# Evaluation of Physical Barriers – TUB-2

Address: Located in the median of State Route 91 freeway

Evaluation Date: 07-19-2021

FLOOR PLAN OF TUB-2

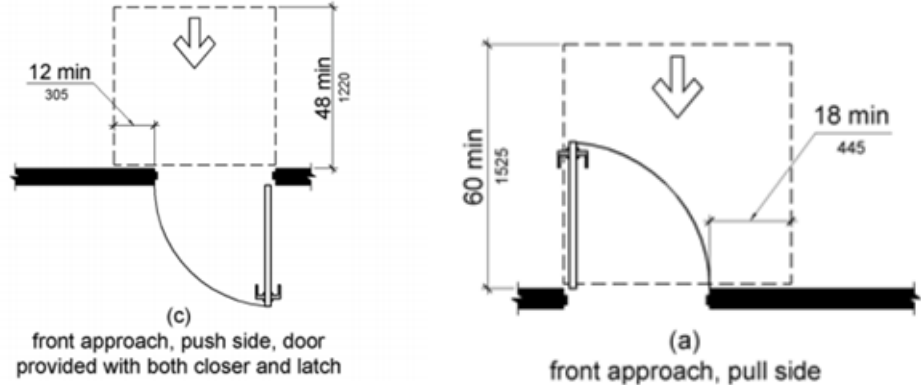
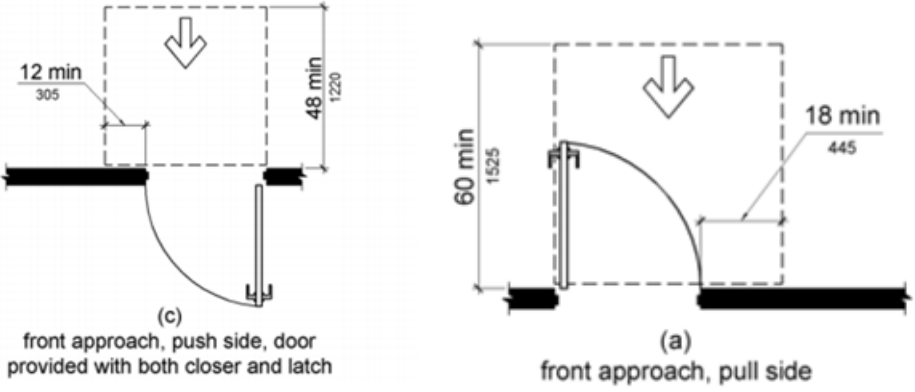
Issues/ Barriers Identified	Recommendations	Comments/ ADA Requirements
<p><b>1. Entry Doors</b></p> <p>i. International Symbol of Accessibility (ISA) sign is missing at the accessible entry door.</p> <p>ii. Maneuvering clearance for the main entry/exit door from inside is reduced by the fire extinguishing apparatus to 9 inches instead of the required 12 inches. Maneuvering clearance for the restroom door is also impeded.</p>	<p>Provide a tactile and visual sign containing raised characters and Braille lettering signs.</p> <p>Relocate apparatus to provide maneuvering clearances required for exiting the space and for entering the toilet room/ or provide automatic door openers</p>	<p>216.2 Designations. Interior and exterior signs identifying permanent rooms and spaces shall comply with 703.1, 703.2, and 703.5.</p> <p>404.3.2 Maneuvering Clearance. Clearances at power-assisted doors and gates shall comply with 404.2.4. Clearances at automatic doors and gates without standby power and serving an accessible means of egress shall comply with 404.2.4. EXCEPTION: Where automatic doors and gates remain open in the power-off condition, compliance with 404.2.4 shall not be required.</p>  <p>Figure 404.2.4.1 Maneuvering Clearances at Manual Swinging Doors and Gates</p>

<p><b>2. Exit Doors</b></p>		Single entry/exit door. See above.
<p><b>3. Exterior Accessible route</b></p>		
<p>i. Handrail extension at top of ramp and stair does not comply with the minimum 12 inch extension requirement on either side. Bottom rail extension is OK.</p> 	<p>Provide compliant handrail extensions.</p>	 <p>Figure 505.10.2 Top Handrail Extension at Stairs</p>  <p>Figure 505.10.1 Top and Bottom Handrail Extension at Ramps</p>
